STAFF RECOMMENDATION
519 Acklen Park Drive
August 16, 2017

Application: New construction – infill and outbuilding
District: Richland-West End Addition Neighborhood Conservation Zoning Overlay
Council District: 24
Map and Parcel Number: 104050S90000CO
Applicant: Aspen Construction, Emily Johns
Project Lead: Sean Alexander, sean.alexander@nashville.gov

Description of Project: The applicant seeks to construct a new duplex with a detached outbuilding.

SITE PLAN
OF
519 ACKLEN PARK DRIVE, NASHVILLE, TENNESSEE

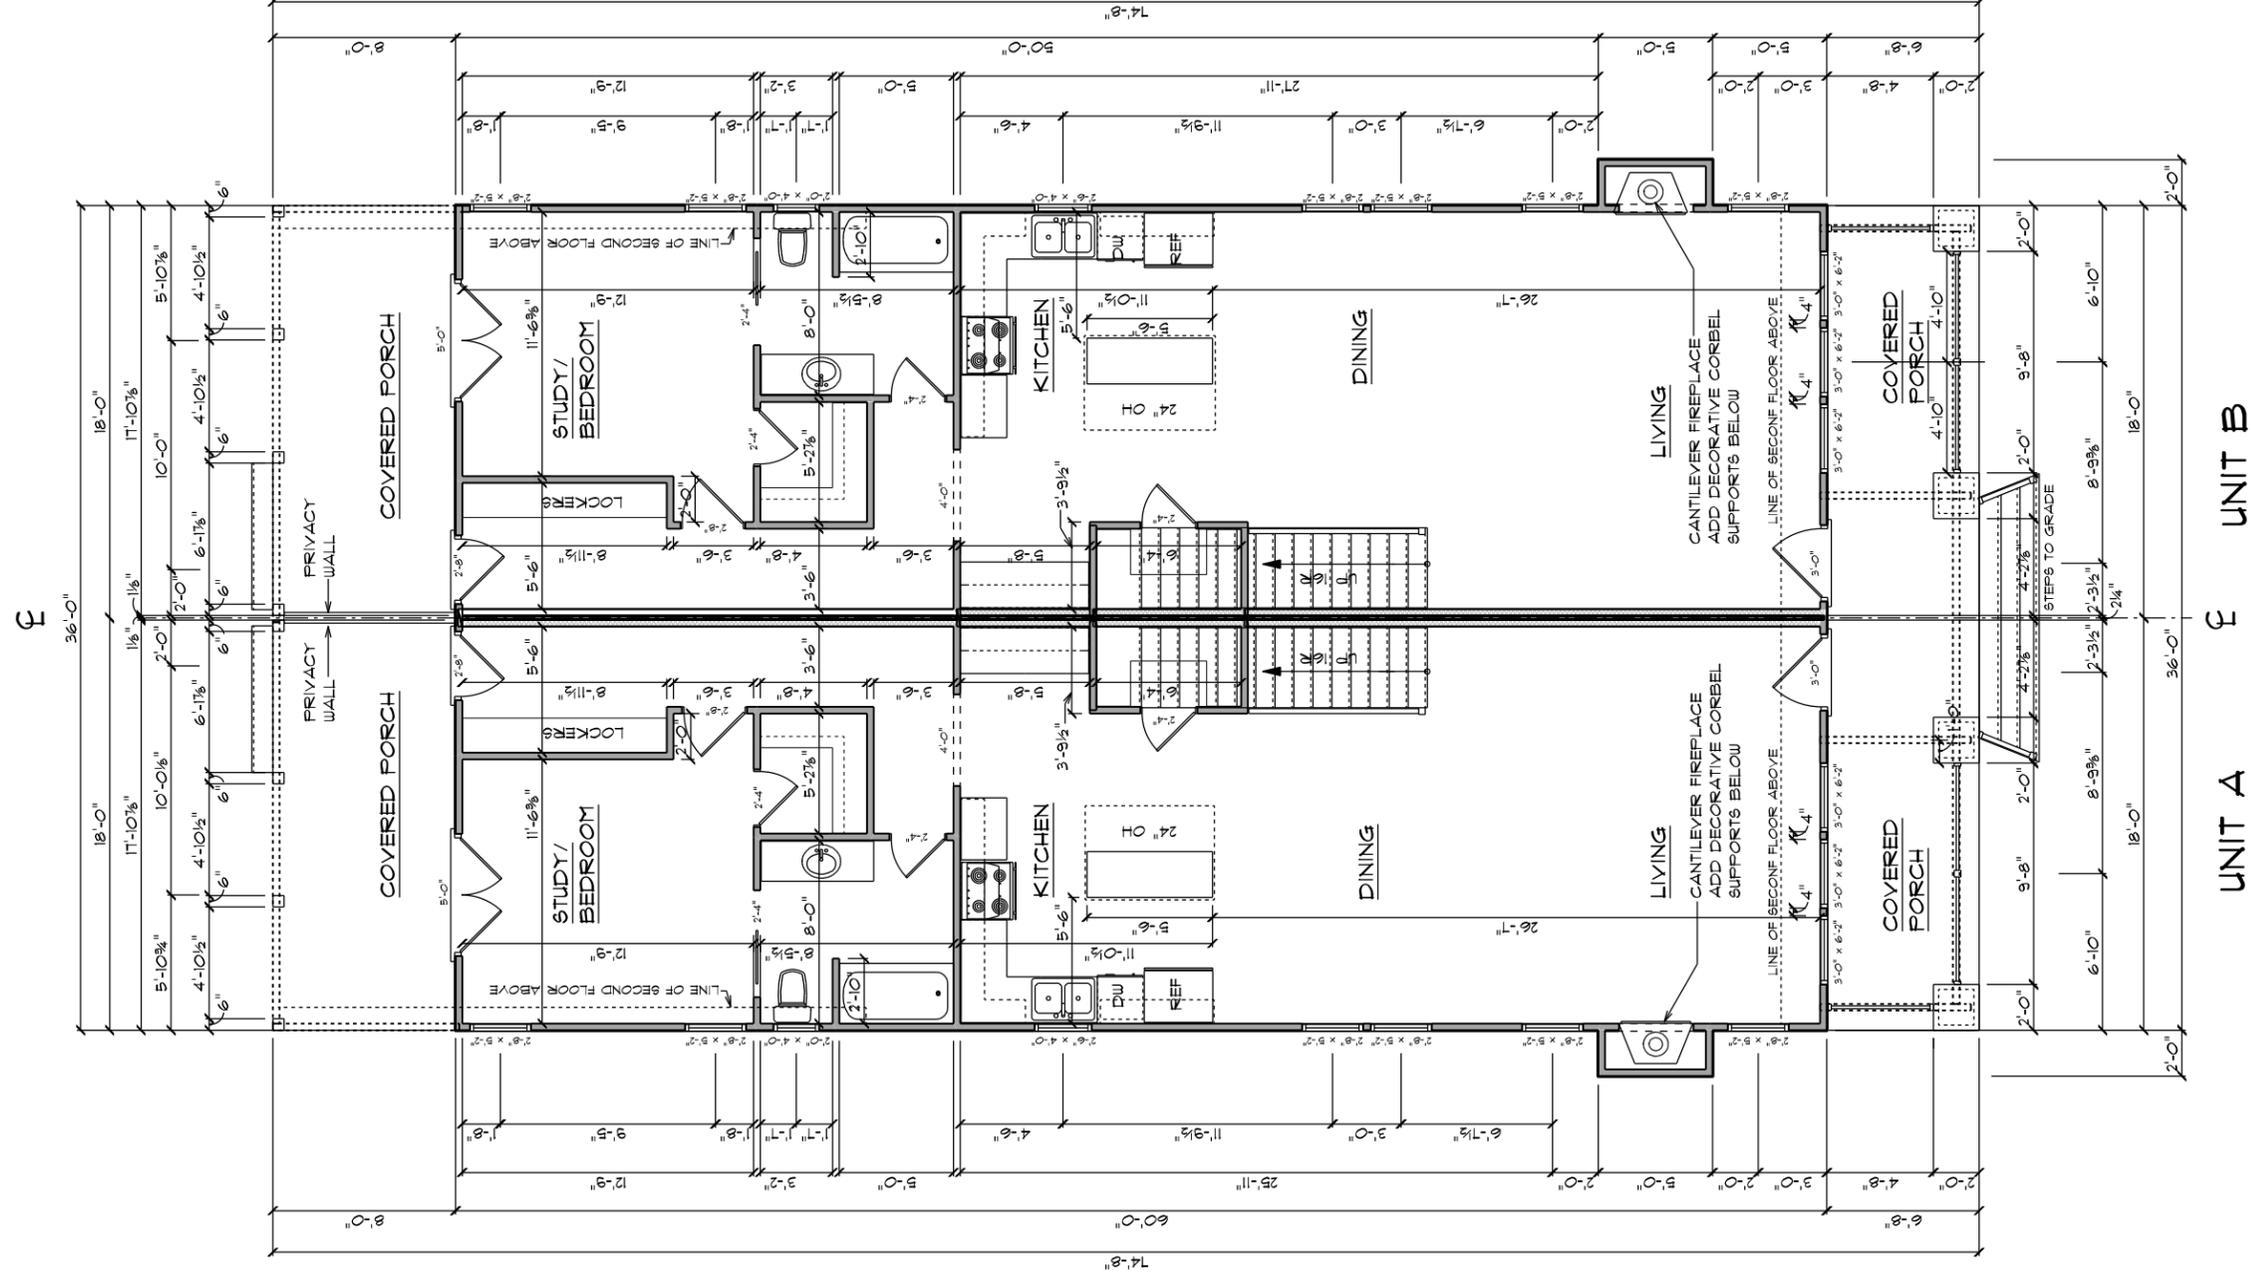
Setback & Rhythm of Spacing: The front of the property is angled to the street, and the lot widens toward the rear. The new building will be located with the left-front corner approximately thirty feet (30') to the street, which is consistent with the front setbacks of existing houses on the street. The side setbacks will be approximately five feet (5') on the left and right. These setbacks meet the requirements of the zoning code and are compatible with the surrounding context. The proposed setbacks and rhythm of spacing will be compatible with the surrounding context and will meet section II.B.1.c of the design guidelines.

The applicant proposes to locate the building at the rear of the lot, with a rear setback of three feet (3'). This setback is typical of the locations of outbuilding historically and meets the design guidelines. Staff finds the proposed location to be appropriate and to meet section III.B.1.i.2 of the design guidelines. The side setbacks also meet the design guidelines and zoning requirements.

GARAGE PLAN

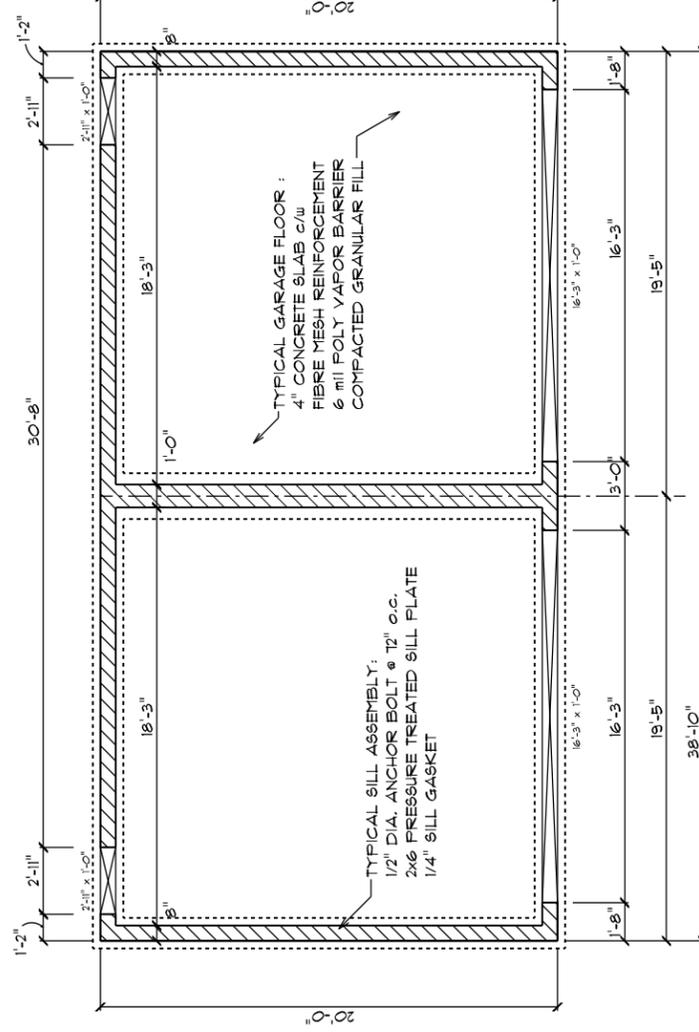
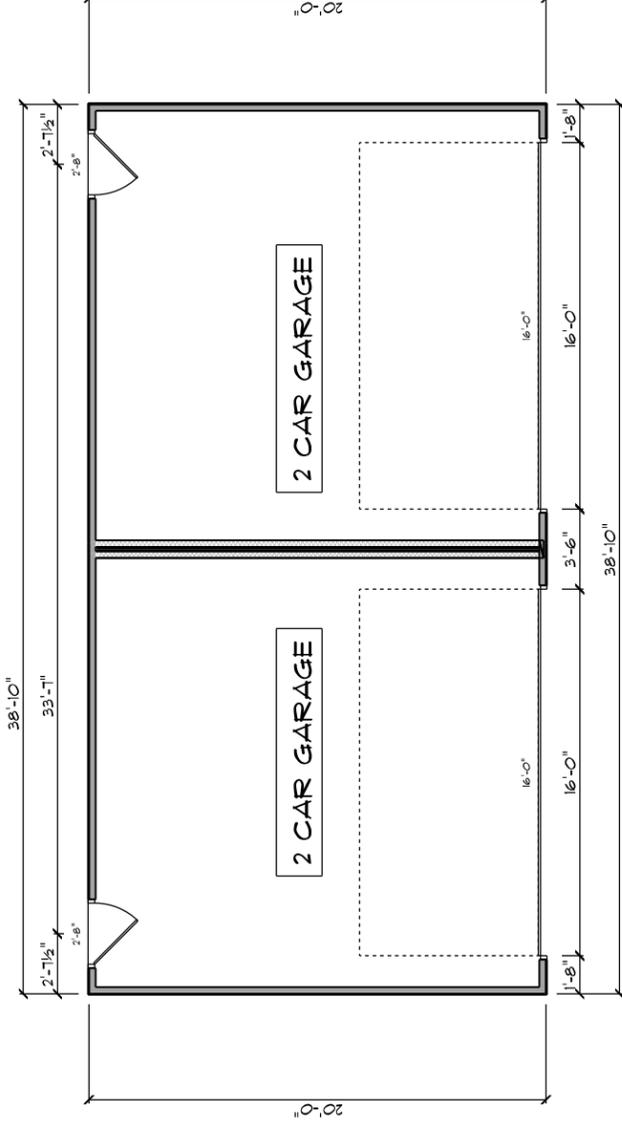
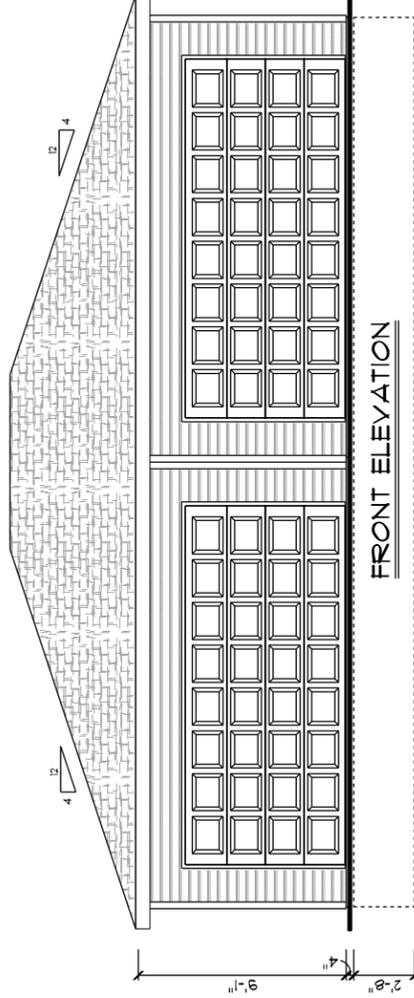
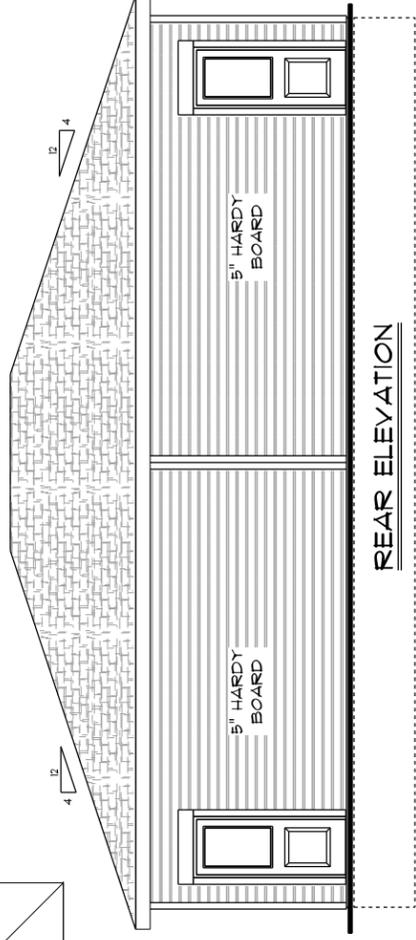
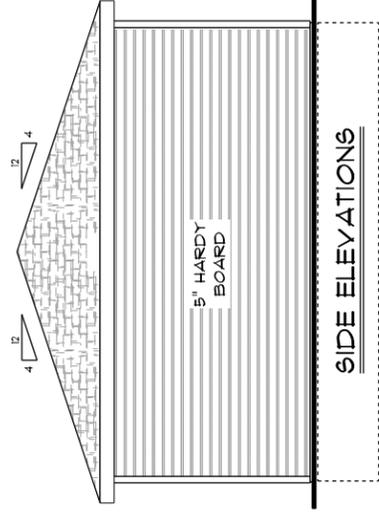
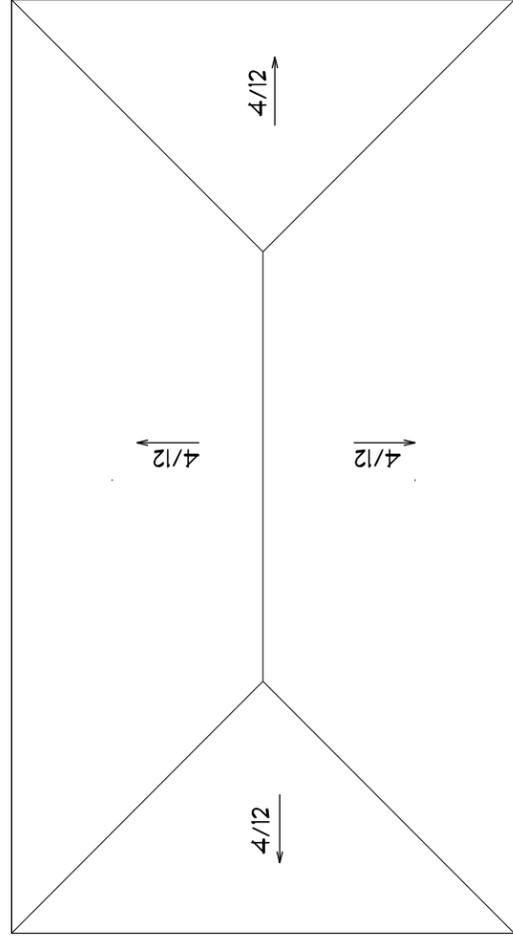
The guidelines would allow an outbuilding to be up to seven hundred, fifty square feet (750 sq. ft.) in footprint size, but the proposed outbuilding exceeds that by twenty-seven square feet (27 sq. ft.). The outbuilding otherwise meets the guidelines for scale and massing of outbuildings. With a condition that the outbuilding is reduced to be no greater than seven hundred, fifty square feet (750 sq. ft.) in footprint size, Staff finds the height and scale of the proposed outbuilding would meet section III.B.1.i.1 of the design guidelines.

1. The porch floors shall be concrete, and that the brick selection for the bases of the porch columns shall be approved administratively; and
2. Windows, doors, and roofing selections shall be administratively approved; and
3. The materials of the walkways and driveways shall be administratively approved; and
4. The front stairs shall not flare at the bottom and there is a single walkway from the street to the porch; and
5. The outbuilding shall be reduced to be no greater than seven hundred, fifty square feet (750 sq. ft.) in footprint size.
